DESIGN 	DRAWN BY RF	DART AEROSPACE LTD HAWKESBURY, ONTARIO, CANADA	
CHECKED 	APPROVED 	DRAWING NO. DSI 9225	REV. A SHEET 1 OF 1
DATE 01.12.13		TITLE D500-572-013 ON LOW GEAR	SCALE NTS
A	01.12.13	NEW ISSUE

DART SERVICE INSTRUCTION

TO AMEND IIN-D500-572 REV. A

REF. CANADIAN STC: SH90-17
US FAA STC: SH849NE

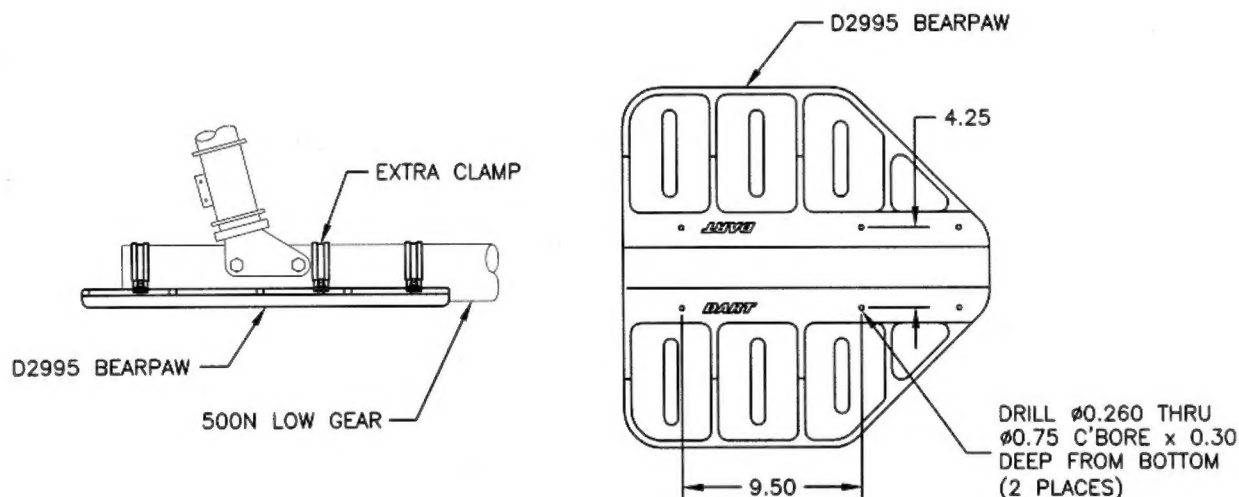
TO FACILITATE INSTALLATION OF THE D500-572-013 BEARPAW KIT ON THE 500N ON LOW GEAR, THE KIT SHOULD BE MOVED FORWARD AND AN EXTRA CLAMP SHOULD BE INSTALLED AS DIAGRAMMED BELOW.
